### Office Action Summary

10/731,210

## **DETAILED ACTION**

*Fig. 1*

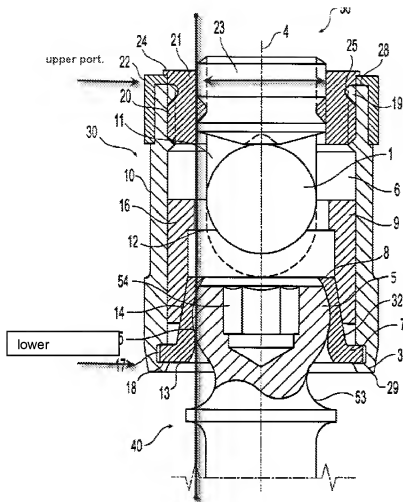
Claims 44-47, 49-52, 54-57, 70-72, and 74-77 are rejected under 35 U.S.C. 103(a) as being unpatentable over Schlapfer et al. (US patent 6, 248, 105) in view of Lombardo (US Publication 2001/0001119). Schlapfer et al. disclose a medical implant apparatus comprising a receiver member (30) having a longitudinal axis (4), an upper portion and lower portion (see drawing below).

Schlapfer also disclose a transverse channel and a longitudinal member occupying this space (1) an interior groove (17) that is substantially perpendicular to the axis, a retaining member (7) that also has an inner and outer dimension and wherein the retaining member occupies the groove (17) and is considered substantially circular and may be considered planar in one perspective, and may be fixed from radial movement depending on how the device is used. Schlapfer further comprises a bone anchor having a head (5) that fits within the receiver member, which is considered

substantially between the retaining member (defined at lower portion and between upper portion). The groove communicates with the lower opening the retaining member substantially surrounds a part, or neck of the bone anchor. Also disclosed is a closure member (23) which assists in maintaining a closed or locked position of the apparatus. It is further noted that Schlaffer discloses an inner crest diameter (shown in drawing as double-sided arrow) which further defines a width which is comparatively smaller than a lower portion diameter. Note line drawn in figure. At least a portion of the retaining member may be considered a crown to be part of the head of the bone anchor.
